**SUBDIVISION REVIEW SHEET****CASE NO.:** C8-2022-0112.0A**COMMISSION DATE:** July 25, 2023**SUBDIVISION NAME:** Velocity Phase 2**ADDRESS:** 3848-1/2 E SH 71 SERVICE ROAD EB**APPLICANT:** VC HOLDINGS QOZ LP (Mark Bulmash)**AGENT:** KFM (Chris Allen)**ZONING:** LI-PDA**NEIGHBORHOOD PLAN:** NA**AREA:** 40.33 Acres**LOTS:** 4**COUNTY:** Travis**DISTRICT:** 2**WATERSHED:** Colorado River and Onion Creek**JURISDICTION:** Full Purpose**SIDEWALKS:** Sidewalks will be constructed along World Drive and Monument Way.**DEPARTMENT COMMENTS:**

## FINAL PLAT

### VELOCITY PHASE 2 SUBDIVISION

**CITY OF AUSTIN –DEVELOPMENT SERVICES DEPARTMENT  
SUBDIVISION APPLICATION – MASTER COMMENT REPORT**

## Exhibit A: Vicinity Map

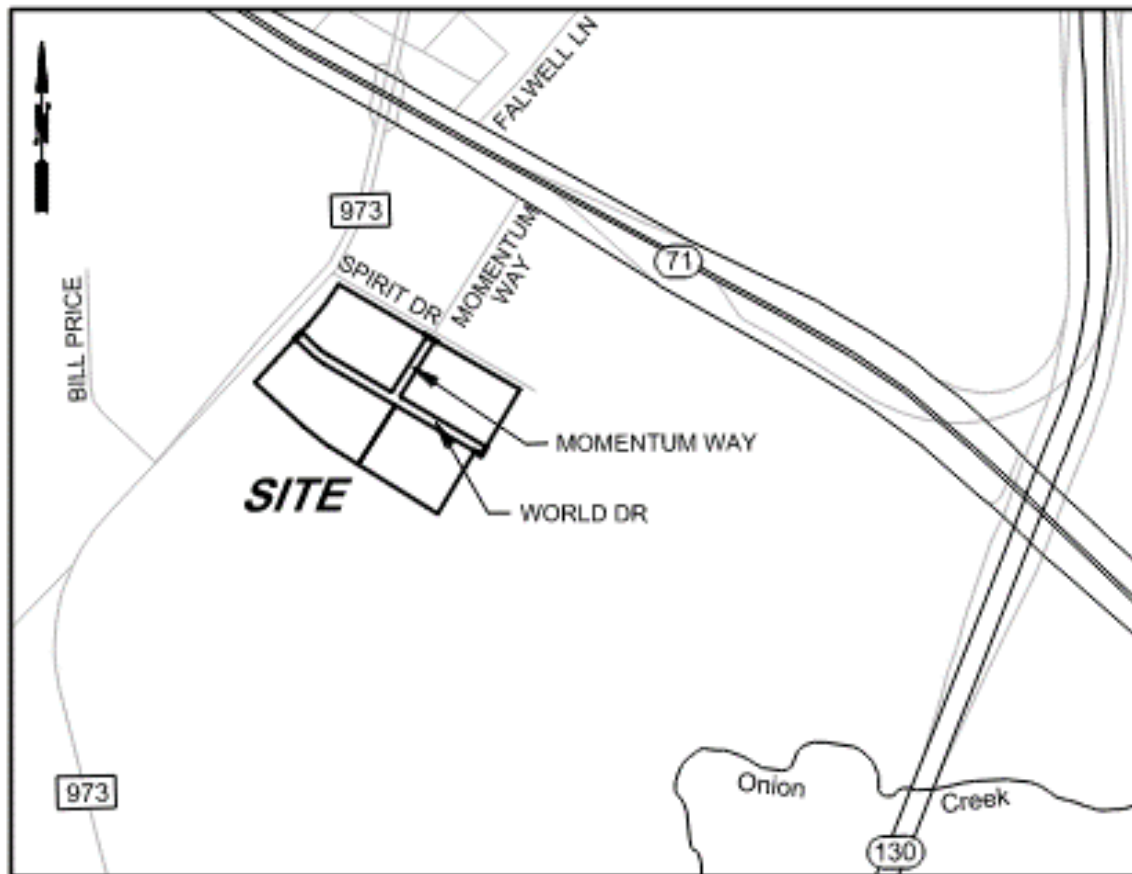
- AD1.** Please update label for **S FM 973 RD** the directional S and street type RD must be included in the exhibit and the vicinity map §25-4-155

SHEET  
1 of 2

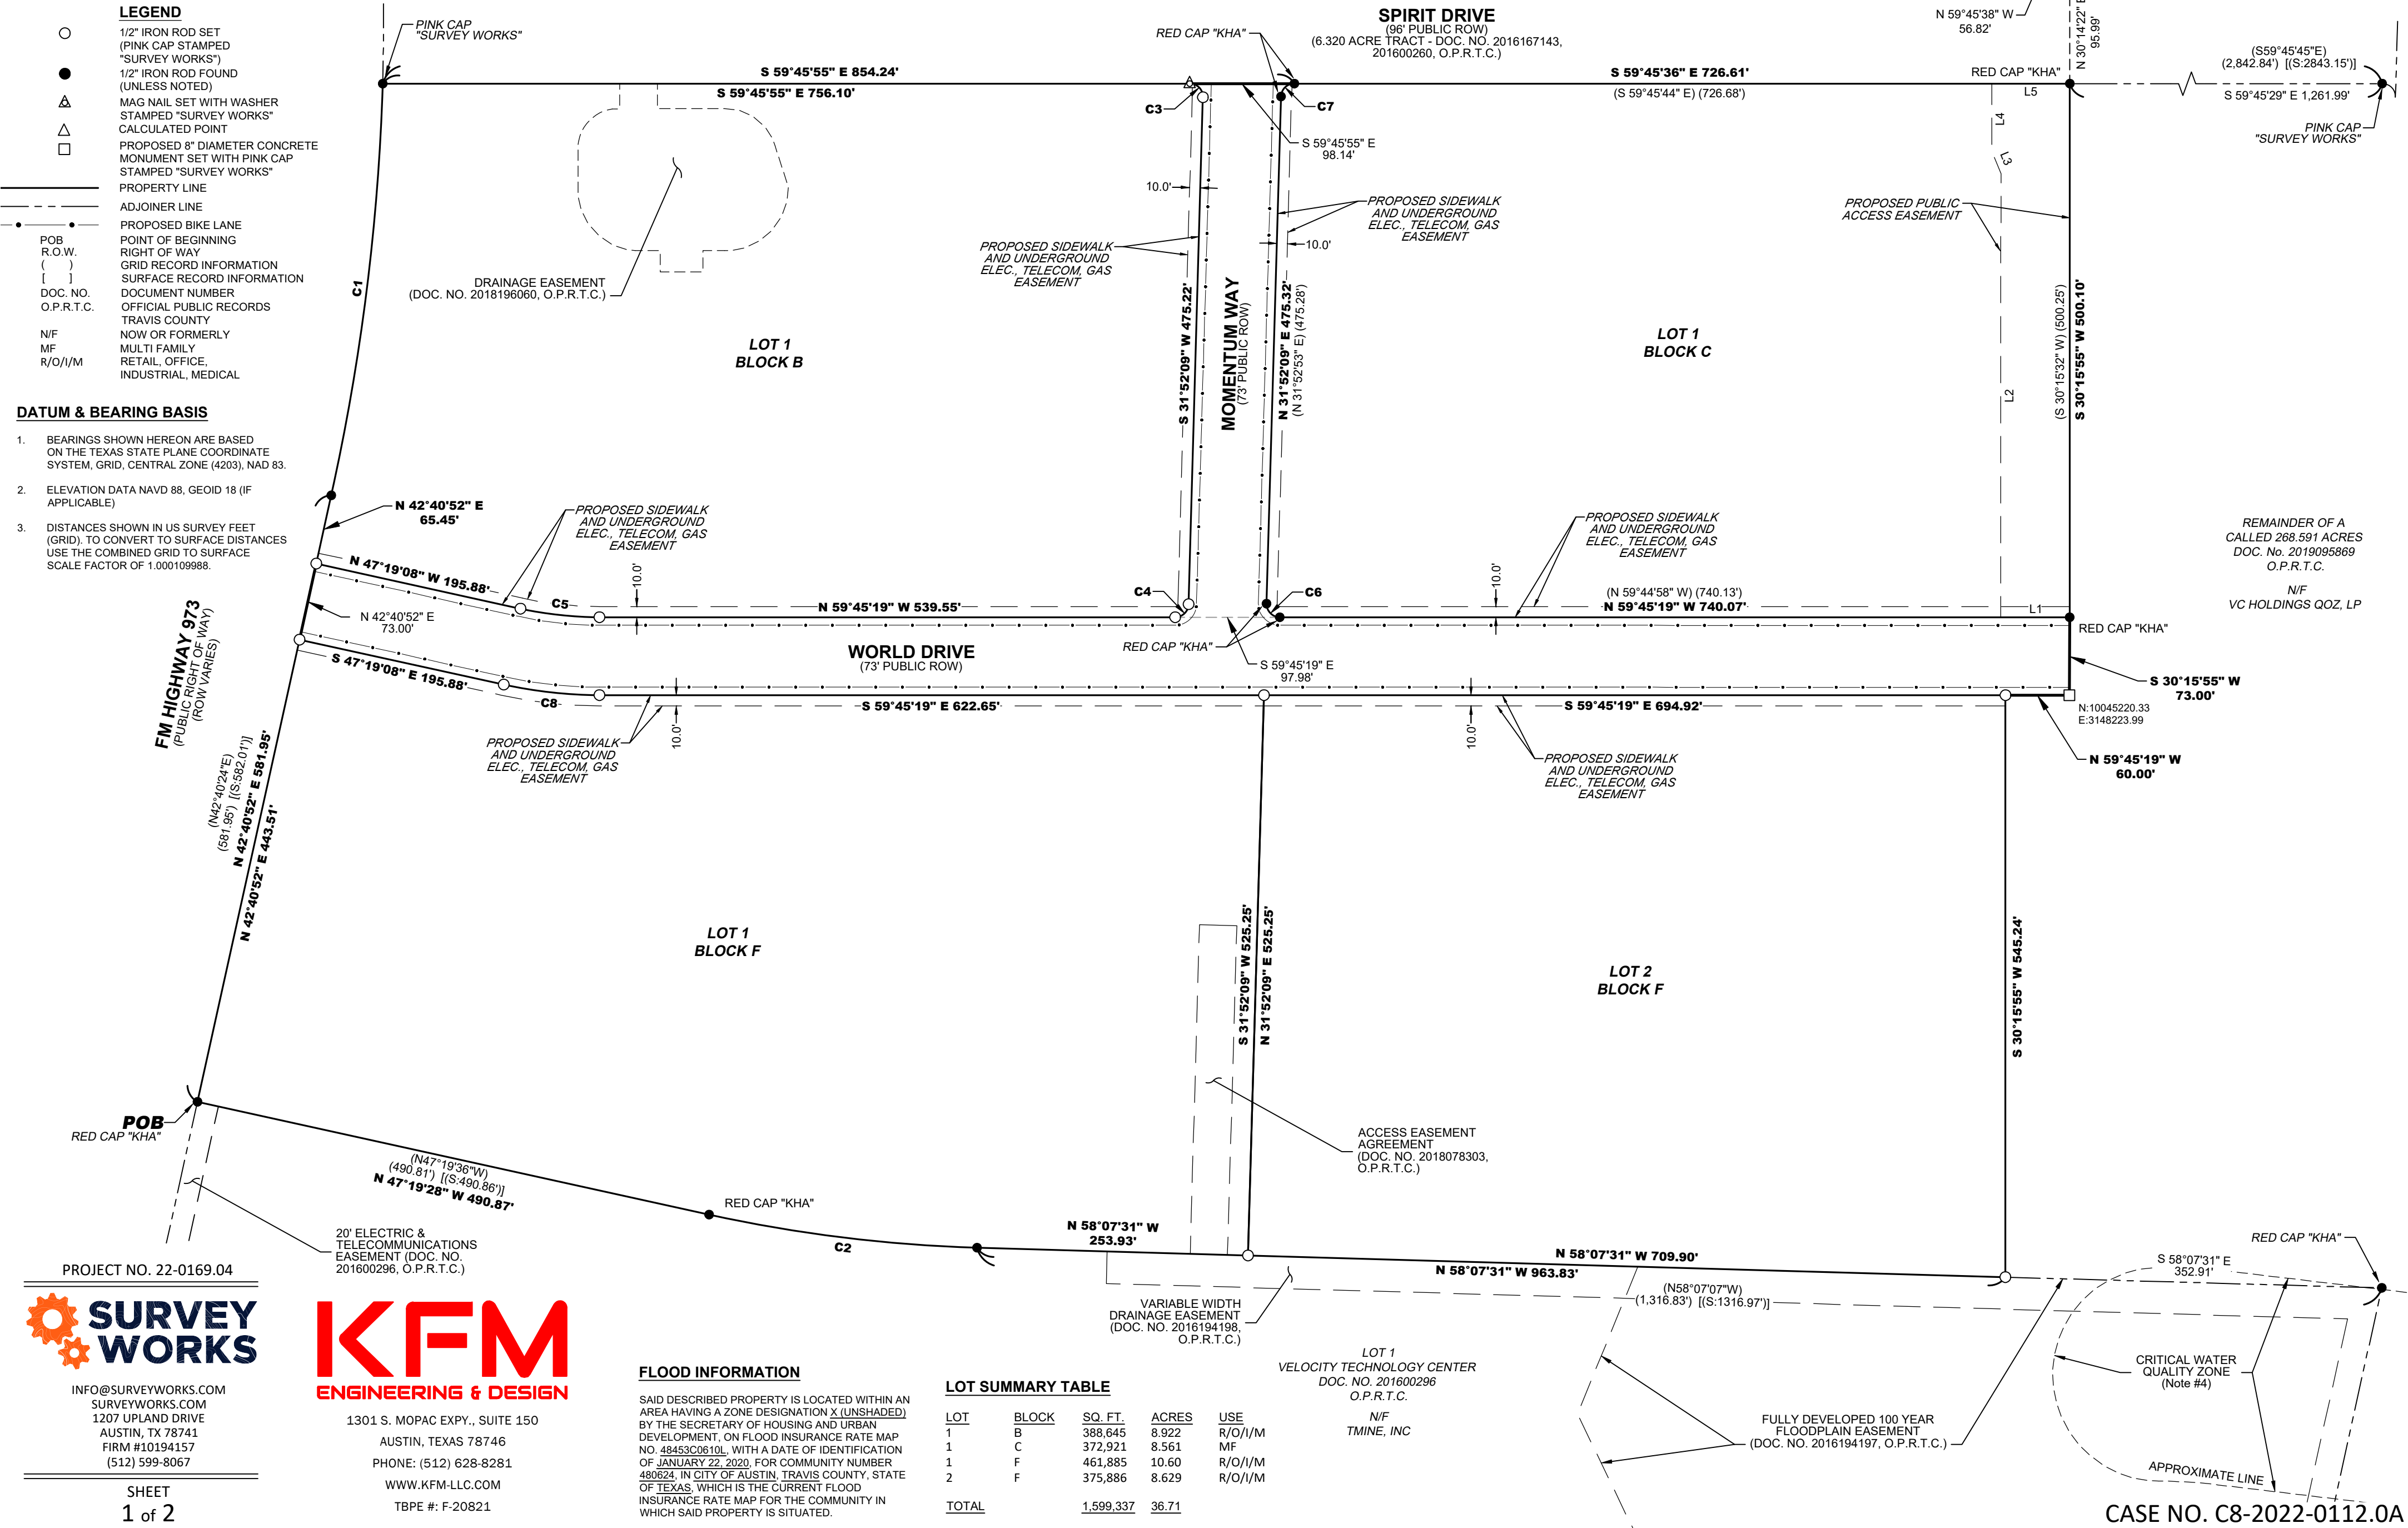
**Fifteen-foot electric distribution, electric telecommunications, and electric fiber easement is required adjacent to all internal and external street R.O.W. Show the easements on the face of the plat.**

- AD2.** Please update label for **E SH 71** the directional E and street type RD must be included §25-4-155

- AD3.** Please update label for **BILL PRICE RD** the street type RD must be included §25-4-155

- ATD1.** The ASMP requires 116 feet of right-of-way for Spirit Drive. Dedicate 59 feet of right-of-way from the existing centerline in accordance with the ASMP (LDC 25-6-55).

- ATD2.** Sidewalks are required on the subdivision side of Spirit Drive. Identify the location of the sidewalks by a dotted line on the final plat and include the sidewalk symbol within the legend. LDC 25-6-351. TCM, 4.1.1. (*Missing Dotted Line Sidewalk Legend*)

- **Fiscal due: December 26, 2023**
  - **All submitted for recording due: January 23, 2024**
- SR2.** Please remove the specific uses from the legend and the lot summary table (25-1-83)

- SR3.** Please place the vicinity map on sheet 1 (25-1-83)
- SR4.** From the approved preliminary plan this section looks to be Phase 1 not Phase 2. Please update the title and anywhere the title appears on the plat to reflect the correct phase from the preliminary plan (25-1-83)

- SR6.** Add Case # C8-2022-0112.0A in the bottom right-hand corner of each sheet. 25-1-83
- SR7.** Please show the amount of property to be dedicated as right of way in the Summary Table on the first sheet (25-1-83)

- SR8.** Show subdivision name and record reference, Volume \_\_\_\_\_, Page \_\_\_\_\_, or Doc# for adjacent platted property. Show owner's name and deed reference for adjacent unplatted property. 25-1-83

**SR11.** One concrete monument is required to be placed at or near a major property corner if one is not located and shown within 1300 feet on previously recorded property. Please remove “proposed” from the legend 25-4-131
